**City of Richmond**  
Planning and Development Department

**Report to Committee**

**To:** Planning Committee  
**From:** Brian J. Jackson, MCIP  
Director of Development  
**Date:** May 6, 2009  
**File:** RZ 06-330589  
12-8060-20-8425  
**Re:** Application by Gerry Blonski, Architect for Rezoning at 11111 and 11131 Cambie Road from "Single-Family Housing District, Subdivision Area E (R1/E) and Two-Family Housing District (R5)" respectively to "Townhouse District (R2 - 0.6)"

**ARBORIST REPORT PLAN**  
 DATE: 1 NOVEMBER 2007

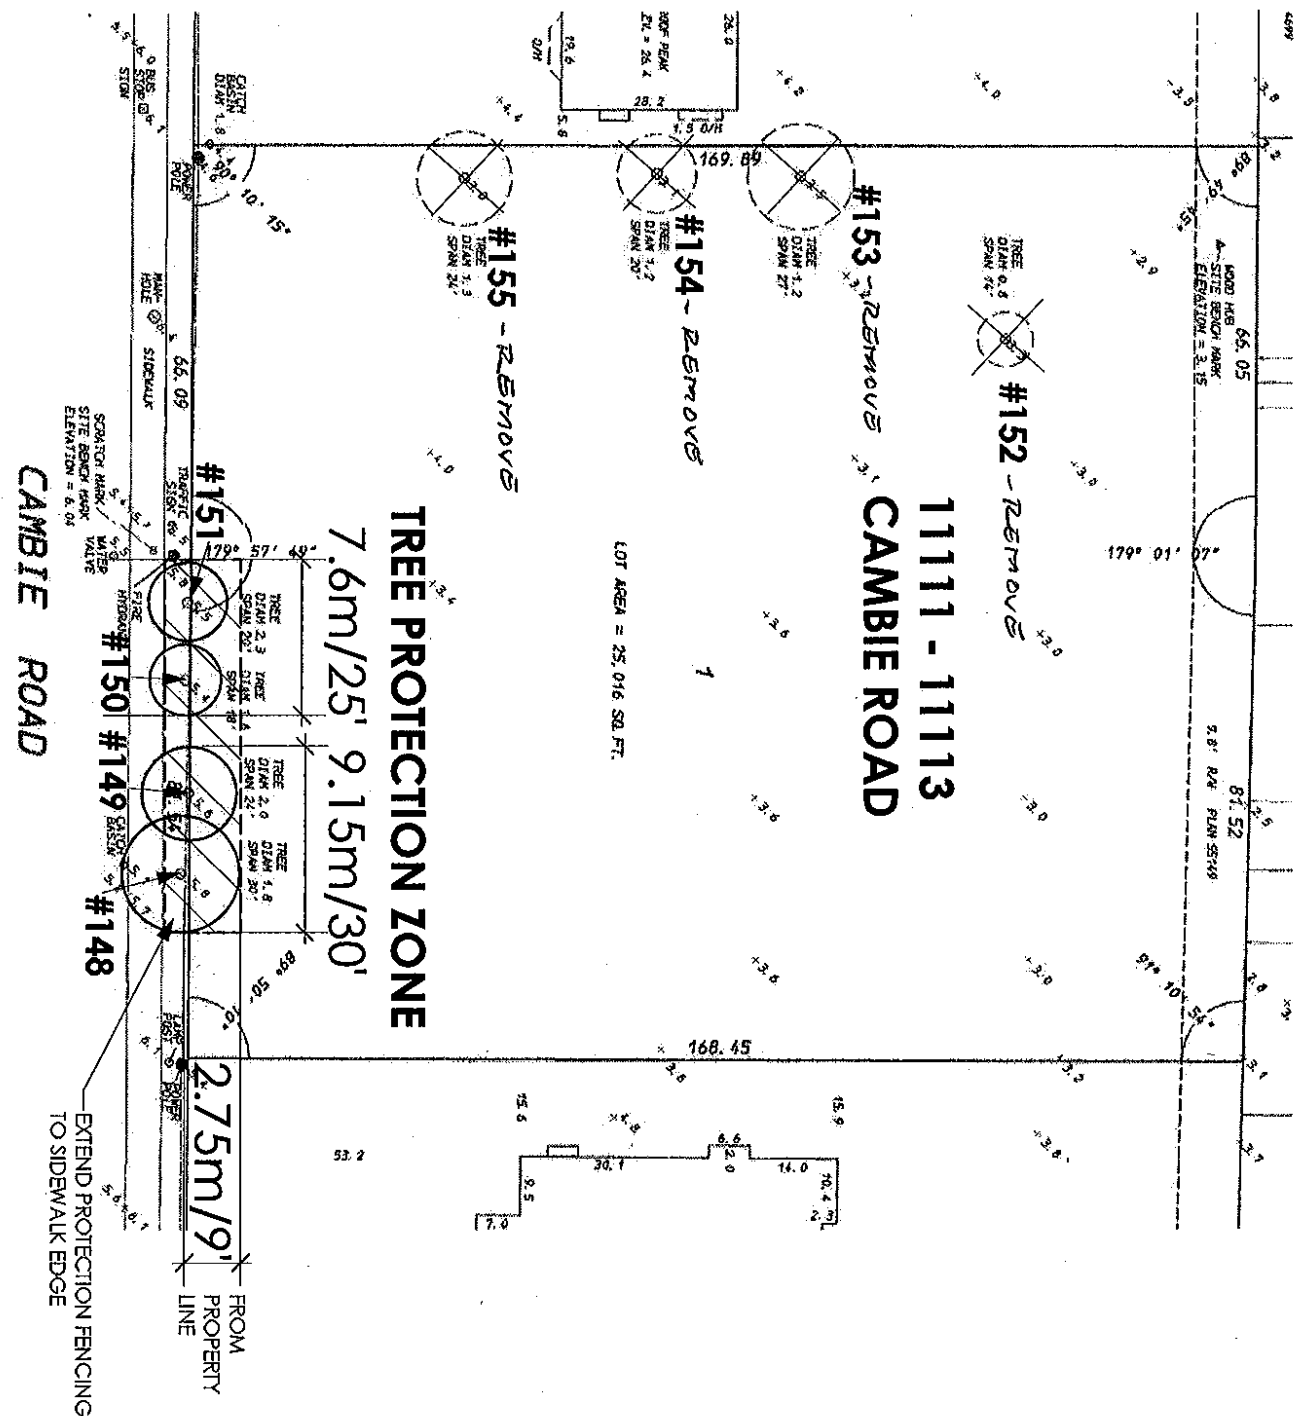
An Arborist report was submitted to assess the four (4) existing trees for possible retention on the subject property and to be incorporated into the upcoming landscaping plan. The trees on the subject site were given a poor rating and therefore, are recommending their removal prior to construction. Tree replacement will be reviewed at the Development Permit stage when more detailed landscaping information is available. A minimum of eight (8) trees will need to be accommodated on-site to meet OCP guidelines.

The report also outlined four (4) street trees under the management of the City and outside the authority of the applicant. These trees will be retained as part of this application.
